MANCHESTER CITY COUNCIL

## Delegated officer report for planning application

| **Application no.** | 139344/LP/2024 |
| **Address:** | 3 Arliss Avenue, Manchester, M19 2PD |

*Image 1 Proposed (part) of ground floor drawing. Orange dashed line indicates side elevation.*

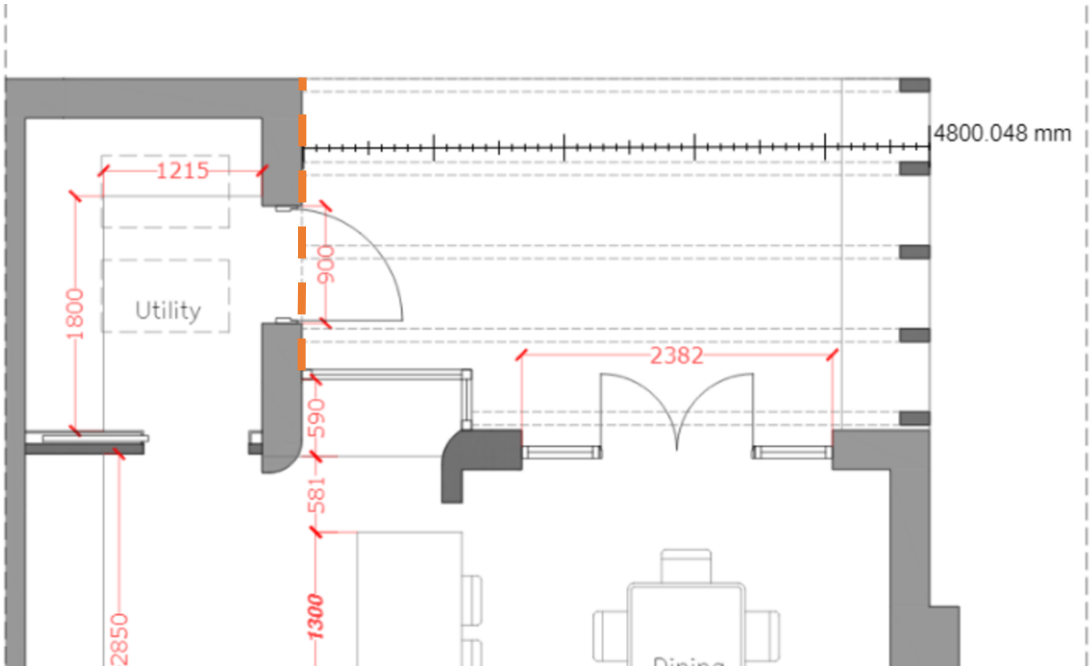
The existing property has an original outrigger for which the proposed canopy/pergola will connect and consequently, extend beyond a wall forming a side elevation of the original dwelling.

Therefore, as proposal would form an extension beyond the side wall (indicated as an orange line below) resulting in an overall width of 4.8 metres and therefore the extension if built would have a greater width than half the width of the dwellinghouse and would not comply with A.1 (j)(iii) of the GPDO.

| Explanation<br><br>The rear canopy/pergola appears to join and extend from the rear of the property, as the proposed materials are timber these will not be similar in appearance to those used in the construction of the exterior of the existing dwellinghouse; in this case a red brick. | |

1) Refuse Part A, on the basis that the proposed timber canopy/pergola to rear patio as shown on the submitted drawings, Pr-043-001, Pr-043-100, Pr-043-101, Pr-043-200 and

Pr-043-201 does not constitute permitted development in accordance with Part 1, Schedule 2, Class A.1(j)(iii) of the Town and Country Planning (General Permitted Development) (England) Order 2015 (as amended), in that the proposed enlarged part of the dwellinghouse would extend beyond a wall forming a side elevation of the original dwellinghouse, and have a width greater than half the width of the original dwellinghouse.

The materials proposed for the canopy/pergola would also fail to accord with Condition A.3(a) of Class A of the Town and Country Planning (General Permitted Development) (England) Order 2015 (as amended).
